CRASH INJURY EVALUATION

U. S. ARMY HU - 1A

BELL IROQUOIS HELICOPTER

TREC Technical Report 60-73

Figure 2. View of the vertical side supports. Arrow 1 denotes the vertical side support; arrow 2 depicts the aft firewall roof support.

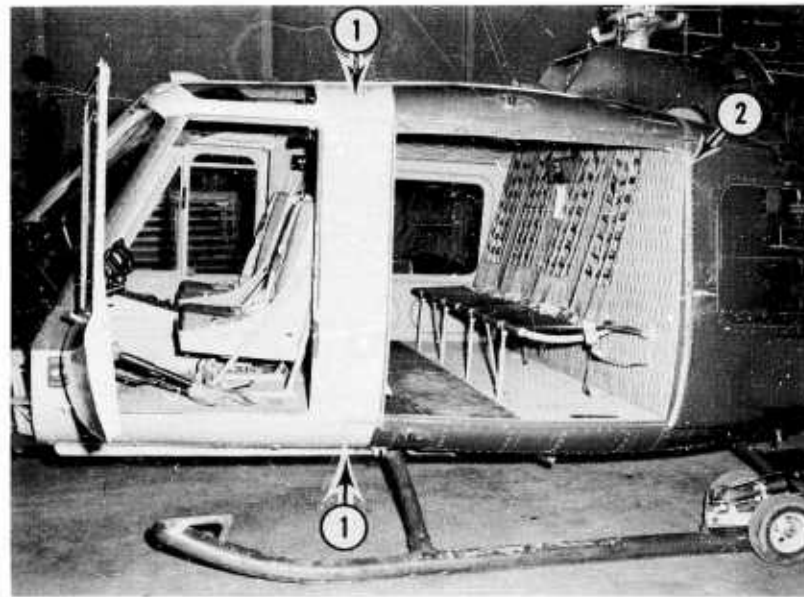
The extreme forward portion of the roof structure of this aircraft is supported by the front door frames and the center strip of the windshield frame structure. The main support is provided by left and right vertical support members shown in Figure 2. The aft end of the roof is supported on a secondary type of structure, the aft firewall bulkhead, also shown in Figure 2.

The lower attachment points of the vertical support members on the right and left side of the cabin consists primarily of two "L" stringers, one fore and one aft. The outer skin of this support extends into the roof structure and is attached to the longitudinal roof support. At the present time, according to the Military Specification, this vertical support is required to carry only a normal air load.

Failure of these main side supports plus the failure of the aft bulk-head support permits the roof structure to lower sufficiently to strike the occupants or the seat backs in the occupiable crew and cabin areas. This is clearly demonstrated by the accident experience where the side vertical supports failed in every one of the five accidents, ranging from partial failure in Accident "C" and Accident "E" to complete failure in Accidents "A" and "D" (Figures 3 through 18). The aft end of the roof also failed in all but one of the five accidents (Figures 19 through 24). Only the absence of forward deceleration probably precluded any forward movement of the aft roof supporting structure in Accident "E".

The Request For Alteration No. 12 in regard to increasing the gauge thickness of the sheet metal structure of the vertical side supports has been approved and is being incorporated into the HU-1B. It is suggested that the second approach, the addition of the roll-over structure, be studied for retrofit of all HU-1A aircraft presently in service.

Figure 34. Over-all view of the instrument panel in the HU-1 and HU-1A. The arrows denote the sharp unprotected lower edges of the instrument panel.

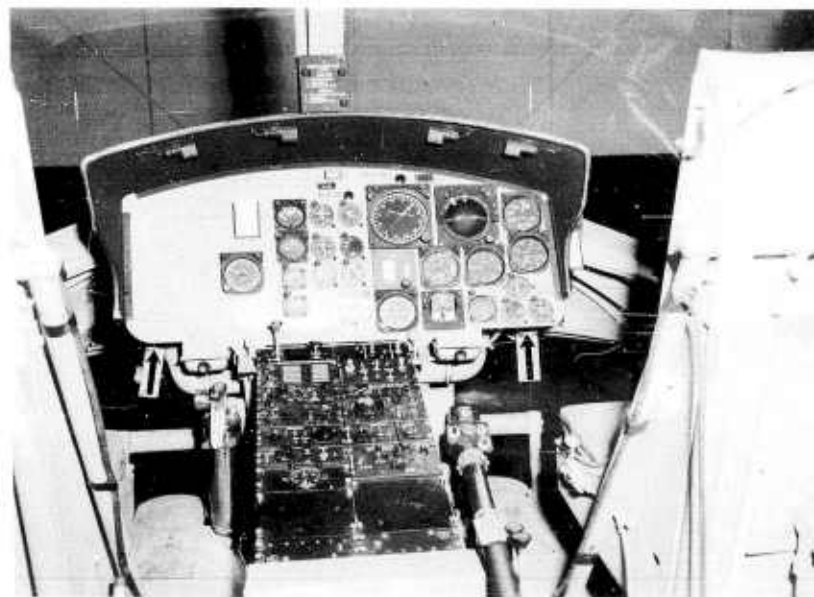
It should be noted that the lower edges of the instrument panel (Figure 34) are quite sharp and unprotected. Statistics reveal that the lower extremities receive the second largest percentage of injuries. The lower edges of the instrument panels should, therefore, be padded with a high energy absorbing material.

Figure 36. Close-up of the safety belt end attachment (arrow). The metal baffle type structure is also depicted.

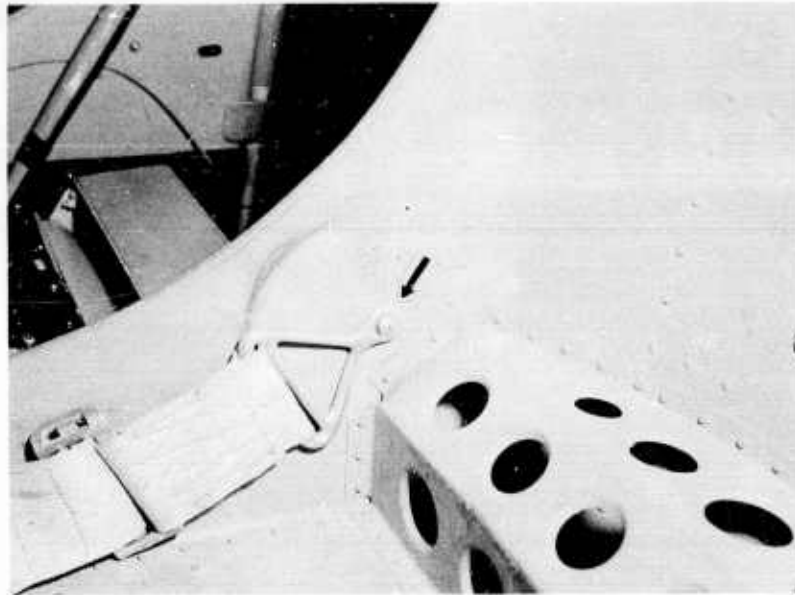
The safety belts on the crew members' seats are attached to the sides as depicted in Figure 36. A reinforcing plate is attached to the outside of the seats for additional strength. It should be noted that this safety belt attachment is not an omni-direction attachment. Helicopters frequently encounter side loads during an accident, and this type of anchorage would have a prying effect on the attachment with possible end attachment failure. It is suggested that the end attachments incorporate a self-aligning omni-directional anchorage.

Figure 47. View of the Crew Chief/Medical Attendant seat mounted in an aft facing position (arrow).

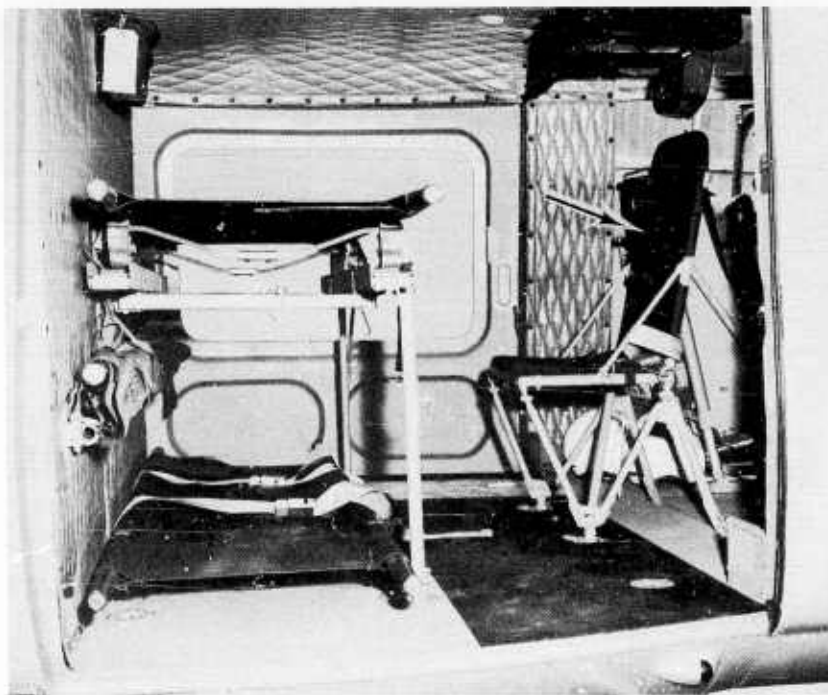
This seat is located just aft of the pedestal and was primarily designed as an aft facing Medical Attendant seat (Figure 47). In some cases the seat is reversed, forward facing, and is utilized by the crew chief. The safety belt is attached at the junction of the seat back and the seat pan and is stressed for 5.0G aft and 10.0G side loads when utilized in the aft facing position.

7. The Military Specification dealing with the tie-down requirement for the Crew Chief/Medical Attendant's seat be revised to provide strength requirements compatible for survivable crash force magnitudes, directions, and time duration; and

Figure 53. The incorrect method of attaching the safety belt to the "O" ring is depicted by the arrow. Note that the belt crosses the occupant at approximately 90°.

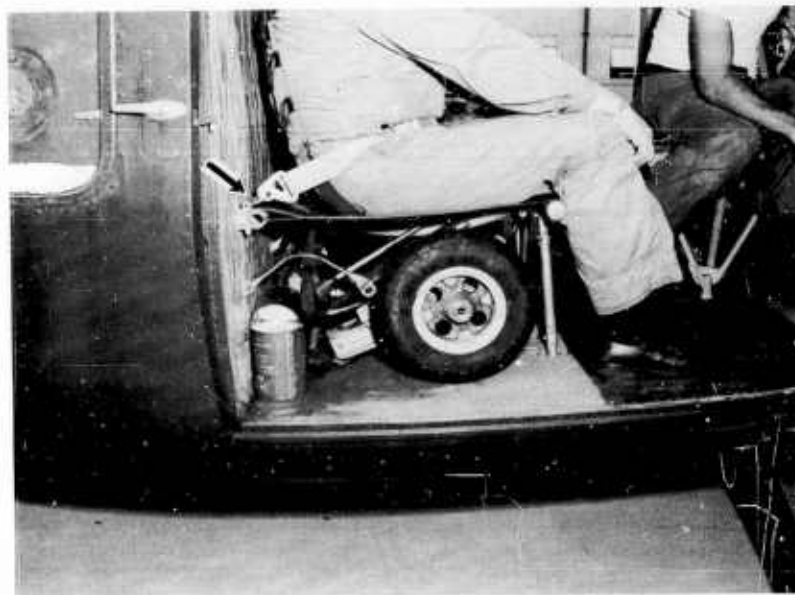
Numerous investigations and evaluations have shown that the cabin occupants' seat belts are being attached to an "O" ring which is attached to a rear longitudinal seat support. The correct and incorrect manner of attaching the seat belts in this aircraft is depicted in Figures 53 and 54.

When the seat belt is attached to the "O" ring, Figure 53, the spine is forced to bend or flex at a much higher level which often causes flexion fractures of the spine.

The incorrect belt installation also permits the seat belt to "ride up" and could cause rib and/or chest injuries due to flexing over the belt buckle, in addition to possible spinal injuries.

The belts are stressed to withstand 11.0G at a 45-degree angle upward, forward, and inboard. The seat belts should be attached to the cables which are tied directly into primary structure (Figure 54).

Figure 54. The correct manner in which the safety belt should be installed in the HU-1 and the HU-1A is depicted by the arrow. Note that the belt crosses the hips at approximately 45°.

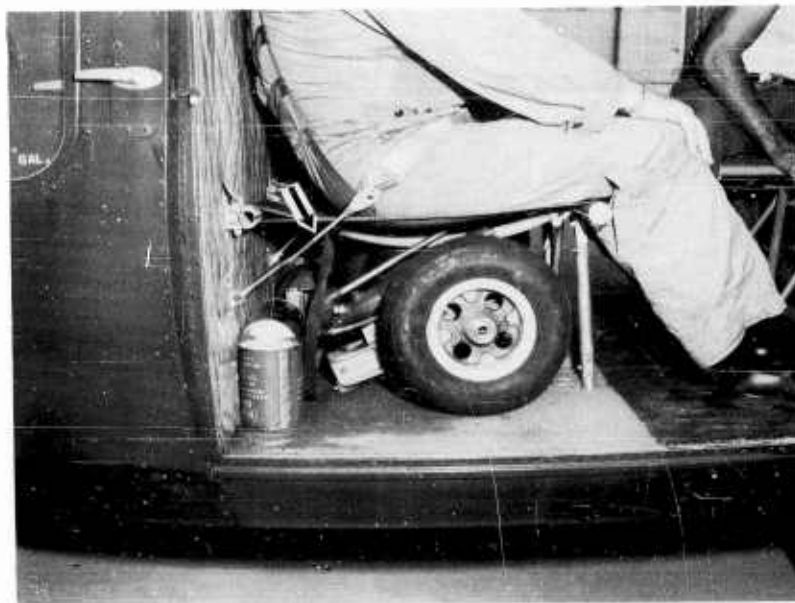
To fully utilize the skeletal strength of the human body, the seat belt should pass across the hips approximately 45 degrees to the longitudinal axis of the airplane. When restrained by a seat belt only, which is common in the cabin area, the occupant's body will flex over the seat belt during a forward deceleration. If this flexing of the body occurs at the lumbo-sacral joint, the strain on the spine will be minimal.

1. The specification for the Army troop seat be revised to provide strength requirements compatible with survivable crash force magnitudes, directions, and time duration;
2. The safety belts be attached to the cables provided in the helicopter in order to afford the occupant maximum restraint;

Figure 55. Over-all view of the litters and supporting frame.

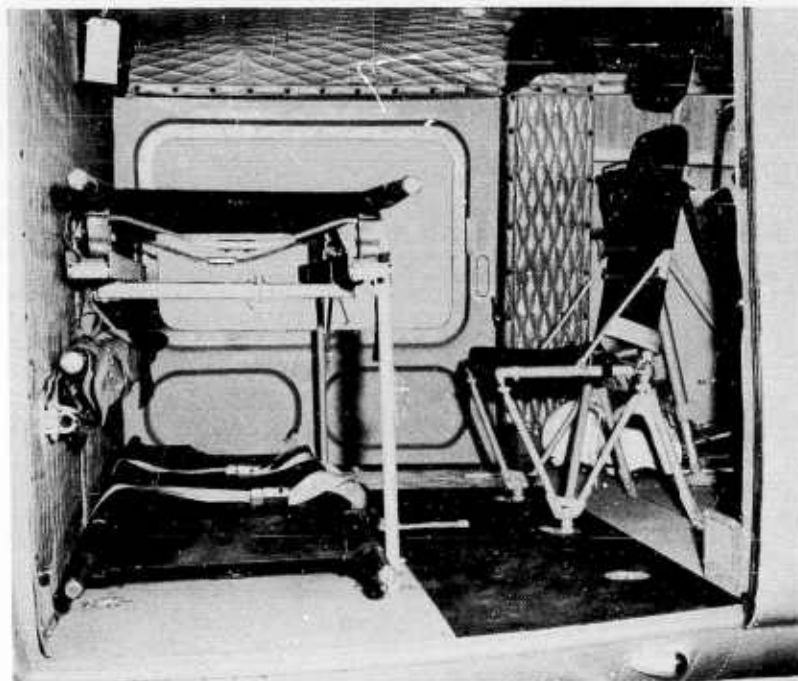
Litter installation requirements (MIL-S-5705, USAF, Appendix II) provide that supports and attachment fittings for litters shall be designed so that they will carry to the primary structure a 250-pound litter load, multiplied by the following ultimate load factors: forward - 8.0G; side - 1.5G; vertical - 4.5G; and down - 2.0G.

While the adequacy of even 8G strength in the forward direction is questionable, the side and vertical minimum strength requirements should be at least equal in helicopters.

The current litter configuration and installation should be dynamically tested with full-scale anthropomorphic dummies under force magnitude, direction, and time history conditions associated with survivable crash loads sustained in helicopter accidents. The results of these tests should be utilized in the development of a more suitable specification.

3. The specifications for Army aircraft litter installation be revised to provide strength requirements compatible with survivable crash force magnitudes, directions, and time duration; and
4. The main cabin door be placarded on the exterior as to the method and direction of operation in a manner that can be easily understood by untrained rescue personnel.

Figure 56. Absence of exterior door operating instructions. The arrow on the left depicts the interior operating instructions. The arrow on the right denotes the absence of exterior door operating instructions.

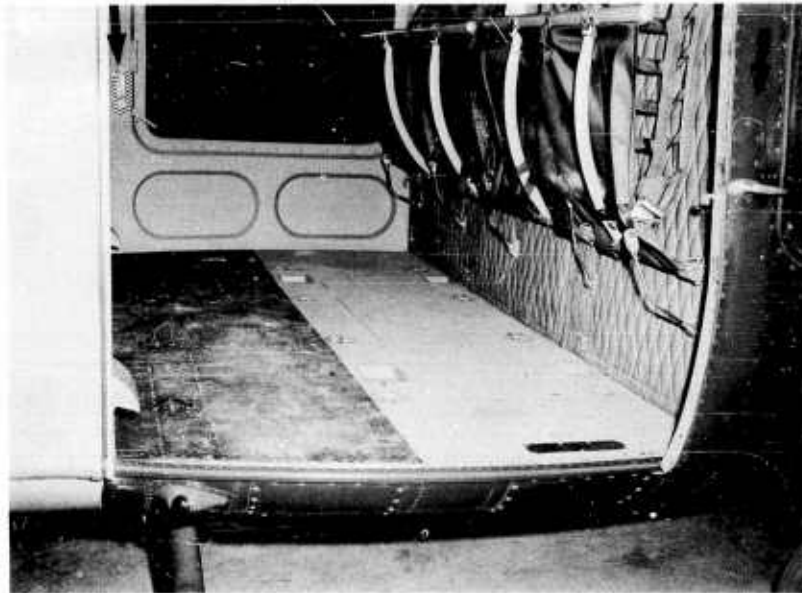
Entrance to the passenger-cargo area is effected by means of two large sliding doors, one located on each side of the aft cabin area (Figure 56).

The large doors permit rapid entrance and departure during combat conditions. In order to prevent inadvertent opening during flight the cabin doors are not jettisonable. In the event of an accident where the doors were rendered inoperable, the large window could be broken or kicked out to provide an avenue of escape. At the present time, however, there are no operating instructions on the exterior of the door to assist untrained rescue personnel.
